REQUEST Current Zoning: R-3 (single family residential)
Proposed Zoning: UR-1(CD) (urban residential, conditional)

LOCATION Approximately 7.69 acres located on the west side of Steele Creek Road, south of Hamilton Road.
(Outside City Limits)

SUMMARY OF PETITION The petition proposes to allow a new 32-unit townhouse community on land with single family homes and vacant acreage in southwest Charlotte.

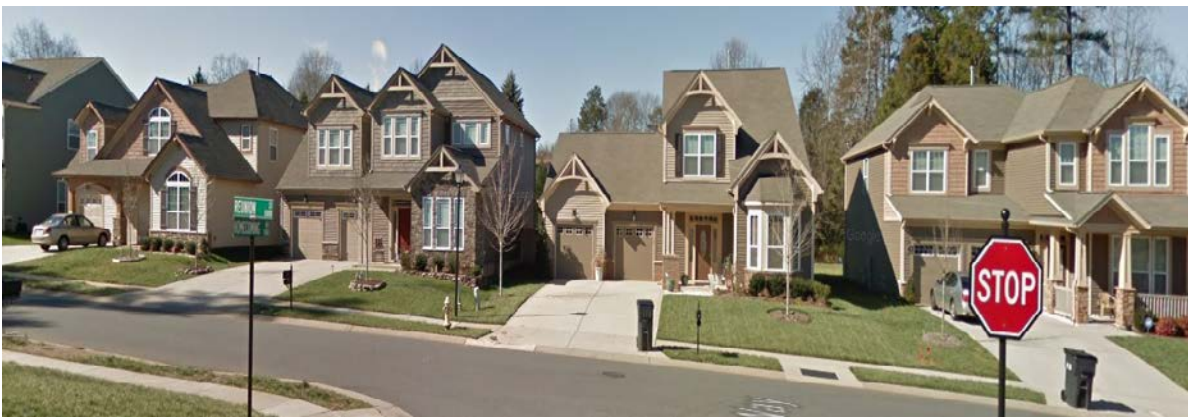
1. The proposed zoning district has a setback measured from back of the existing or proposed future curbline. The proposed cross section for the NCDOT widening project U-5766 has been updated. Based on the new cross section, the location of the future back-of-curb for:

- a. Steele Creek Road – 42 feet from centerline of the road (reduced from 53 feet)
 - b. Hamilton Road – 20.5 feet from centerline of the road (reduced from 28 feet)

2. Revise the site plan to show:
 - a. The back of multi-use path on Steele Creek Road located 65.5 feet from centerline of the road.
 - b. The back of multi-use path on Hamilton Road located 40.5 feet from centerline of the road.

3. The right-of-way for Steele Creek Road is shown incorrectly on the updated site plan. Furthermore, the updated cross-section for the NCDOT widening project U-5766 has changed the right-of-way. The petitioner should revise the site plan and conditional notes to show the dedication of right-of-way, fee simple, of 66 feet from centerline of Steele Creek Road (reduced from 75 feet).

4. Revise the site plan to show the correct existing right-of-way on Hamilton Road of 60 feet wide total, 30 feet from centerline of the road.

5. Reduce the building height to no greater than 40 feet so as to be in character with nearby single family residential neighborhoods.
